## Advanced Digital Design with the Verilog HDL

#### **Errata and Revisions**

Rev 04/13/2004

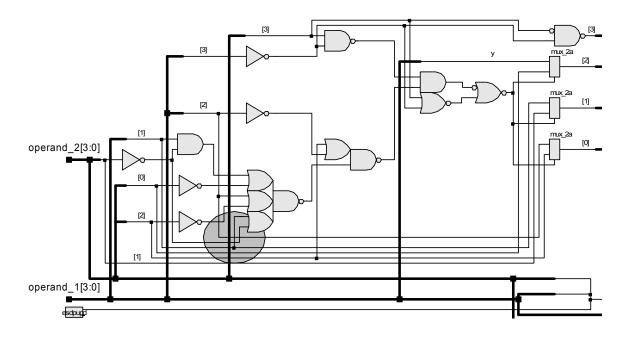
- p. 72: Change S' and R' to S and R in Figure 3-2.
- p. 79: The inputs labeled OE in Figure 3-13 should have a bubble.
- p. 88: The cells of the Karnaugh maps in Figure 3-21 should contain "x" when  $q_2q_1q_0B_{in}$  = 0101
- p. 89: Add a reset line to the flip-flops in Figure 3-22.
- p. 94: Add a reset line to the top flip-flop in Figure 3-29.

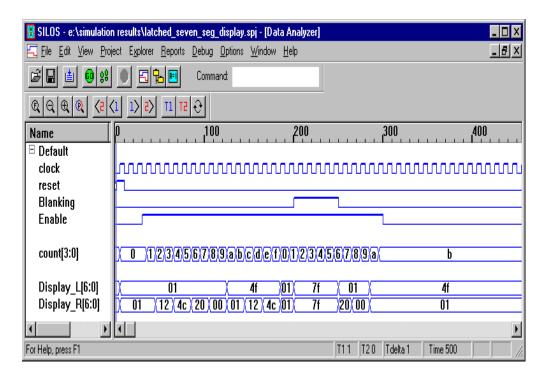
- p. 232 The description of the behavior of the arithmetic shift in problem 5.39 should say that a right shift loads the MSB back into the MSB.
- p. 250 Replace Figure 6-16 with the the figure below.
